SUBJECT: NuScale Power, LLC Response to NRC Request for Additional Information No. 03 (eRAI No. 8744) on the NuScale Design Certification Application

RAIO-0617-54560

Enclosure 1: NuScale Response to NRC Request for Additional Information eRAI No. 8744

eRAI No.: 8744

Figure 15.2-44: Hot Channel Node MCHFR - Peak RCS Pressure Limiting MCHFR Case (15.2.8 Feedwater Line Break)

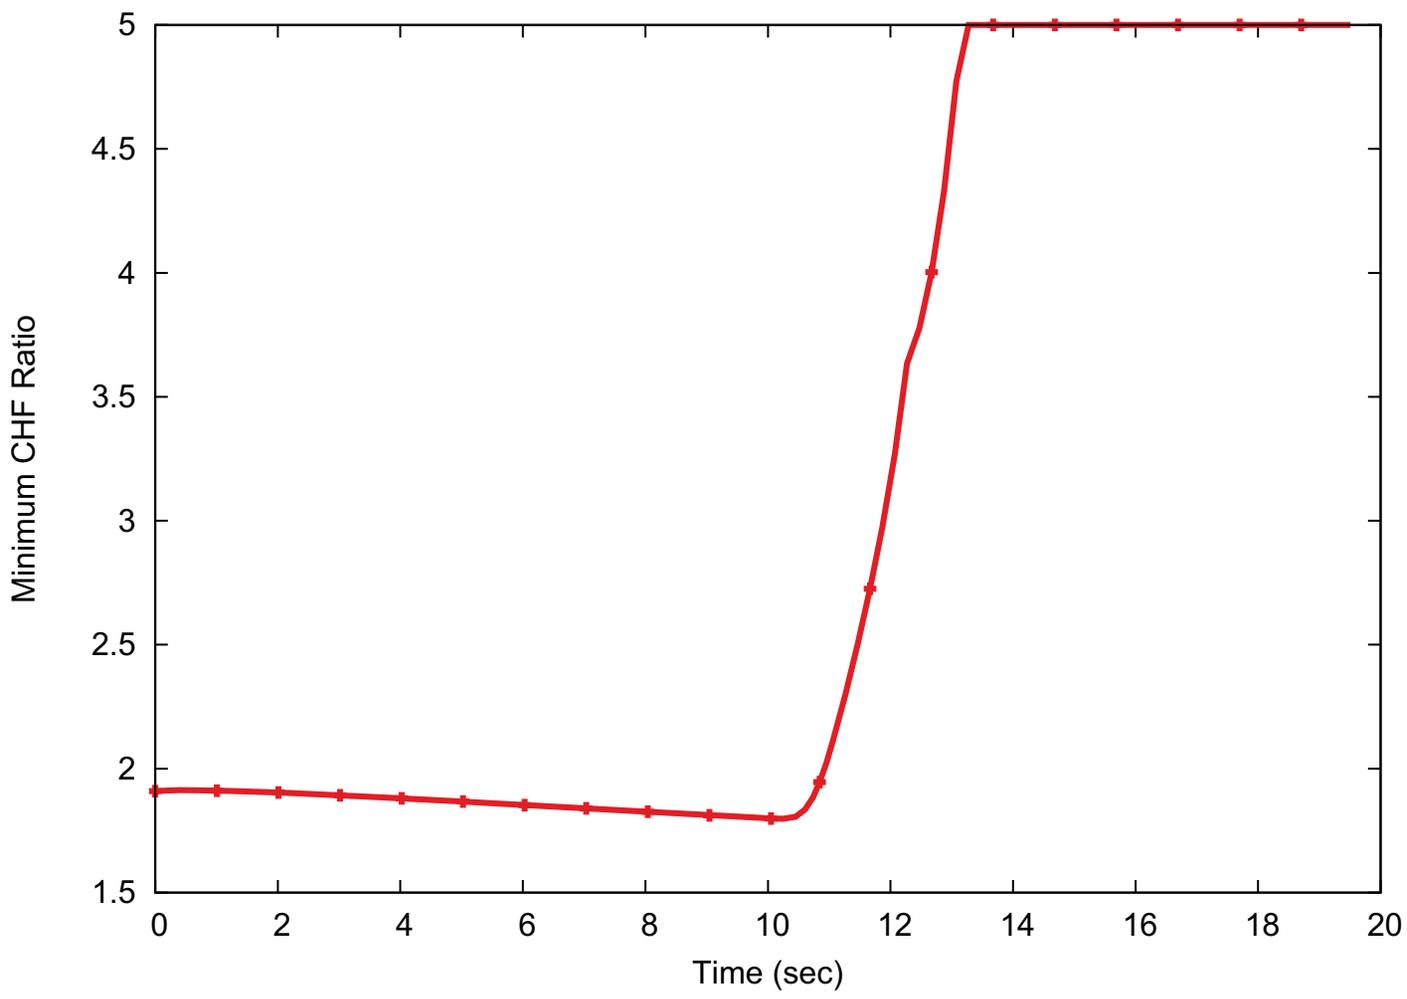
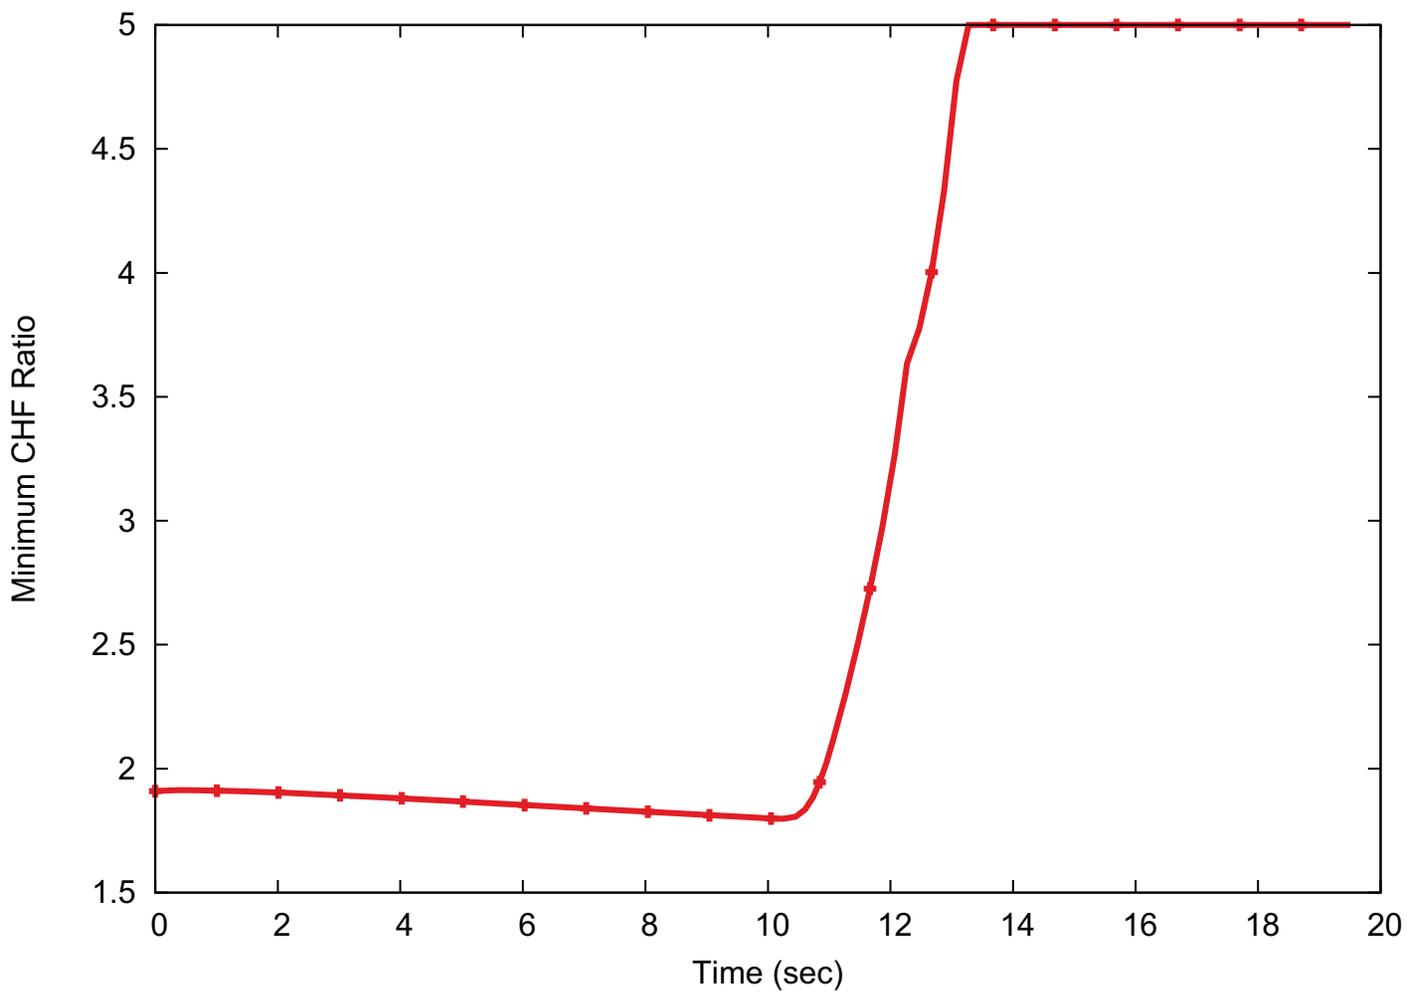
In Final Safety Analysis Report (FSAR) Tier 2, Section 15.2.8.4, "Input Parameters and Initial Conditions," the applicant states that a 30% uncertainty is added to the steam generator heat transfer. However, in FSAR Tier 2, Table 15.2-28, "Biases and Uncertainties - Feedwater Line Break," the applicant states that a -30% uncertainty is used for the steam generator heat transfer. The staff notes that these statements in the FSAR are inconsistent. Based on the docketed information, the staff is unable to determine what uncertainty value is used for the steam generator heat transfer and the adequacy of the reported 30% uncertainty addition to the steam generator heat transfer. The staff requests the applicant to clearly state in the FSAR which uncertainty value is used and provide justification in the FSAR as to why the applicant adds to (or subtracts from) the steam generator heat transfer.

For the DEG FWLB evaluated for the limiting SG pressure, the highest pressure was obtained by using a positive 30% heat transfer bias, no fouling and no SG tube plugging. However the DEG FWLB was not the limiting break for SG pressure. Smaller breaks of 8% to 10% of feedwater flow with a negative 30% primary to secondary heat transfer bias, a large fouling factor and 10% tube plugging, resulted in slightly higher SG pressure. The 10% FWLB with failure of the feedwater isolation valve (FWIV) backflow prevention device was selected as the representative limiting SG case for the sequence of events FSAR Table 15.2-25 and SG pressure FSAR Figures 15.2-42 and 15.2-43. Similar FWLBs, 4% to 8% break size, with the same heat transfer biases, resulted in the minimum critical heat flux ratio (MCHFR). The 8% FWLB was selected as the representative limiting MCHFR case for the sequence of events in FSAR Table 15.2-26 and MCHFR Figure 15.2-44. Note that the title of FSAR Figure 15.2-44 was mislabeled as the MCHFR for the “Maximum RCS Pressure Case” and has been corrected to be the “Limiting MCHFR Case” as shown in the attached FSAR markup.

FSAR Sections 15.2.8.2, 15.2.8.4, 15.2.8.5, and FSAR Figure 15.2-44 have been revised as described in the response above and as shown in the markups provided in this response.

Figure 15.2-44: Hot Channel Node MCHFR - ~~Peak RCS Pressure~~ Limiting MCHFR Case (15.2.8 Feedwater Line Break)
